Application Revision Requiring Re-Circulation:  
Zoning Bylaw Amendment Application 195  
Huntmar Road,  
File No. D02-02-16-0055.  
Fee \$3250.00 (No HST)

Re: Application Revision Requiring Re-Circulation: Zoning Bylaw Amendment  
Application 195 Huntmar Road, File No. D02-02-16-0055

**Re: Shenkman/Cavanagh – Kanata West  
195 Huntmar Community Transportation Study – Addendum #1**

Figure 3: Revised Palladium Drive Extension Alignment

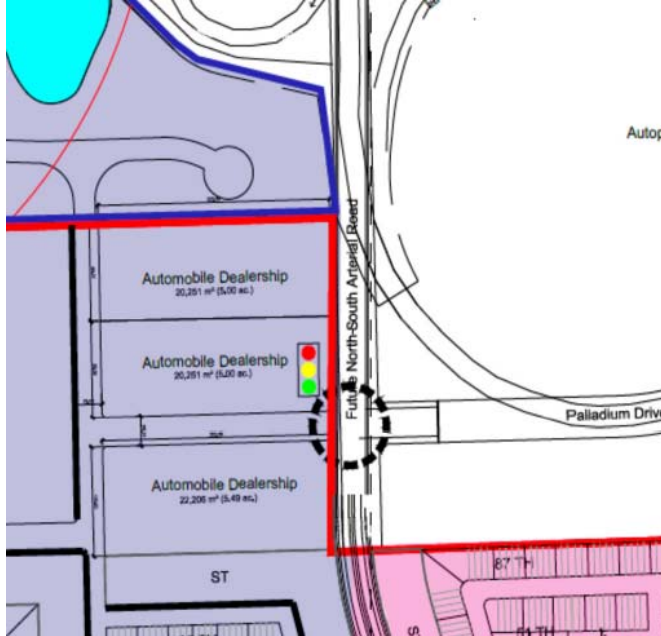
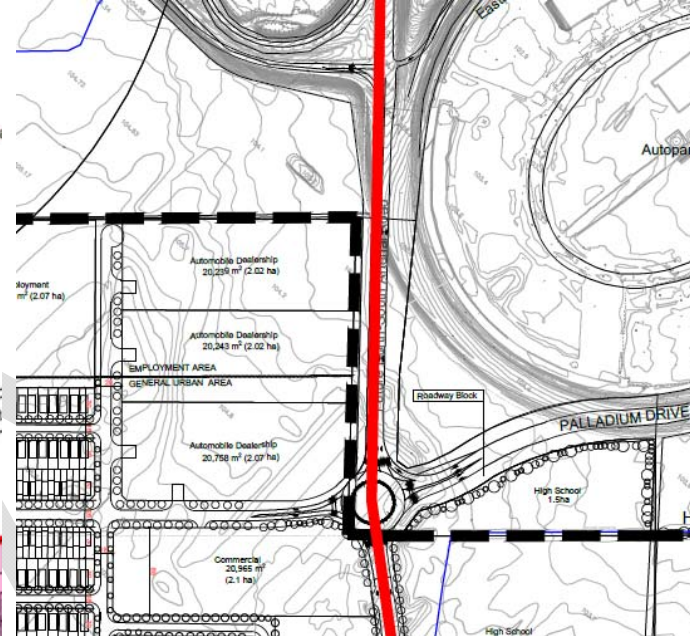
Within the original CTS, the location of the Palladium Drive extension to the North-South Arterial was proposed approximately 350m north of the planned North-South Arterial/Stittsville Main roundabout intersection and approximately 300m south of the HWY 417 eastbound off-ramp. Through consultation with the Ministry of Transportation of Ontario (MTO), we were advised that the location of the proposed Palladium Drive extension to North-South Arterial is too close to the HWY 417 eastbound off-ramp. Through further consultation with the project team, the City, and adjacent land owners, a revised location of the proposed Palladium Drive extension to North-South Arterial is proposed. The revised location is approximately 400 m south of the HWY 417 off-ramp and approximately 250 m north of the North-South Arterial/Stittsville Main intersection. The original proposed location and the revised location are shown as Figures 2 and 3, respectively.

The following revisions to the Palladium Drive Extension and North-South Arterial intersection are presented:

- The revised Palladium/N-S Arterial intersection is proposed to be a multi-lane roundabout;
- The intersection is located approximately 400 m south of the HWY 417 eastbound off ramp;
- The intersection is located approximately 250 m north of the proposed N-A Arterial/Stittsville Main intersection;
- To accommodate this alignment, the land south of the Palladium Drive extension has been acquired by the proponent and will be incorporated into the proposed development as part of the high school lands;
- This revised alignment improves east-west connectivity to the site by aligning Palladium Drive with the east-west collector roadway that continues through the site to Stittsville Main Street extension.
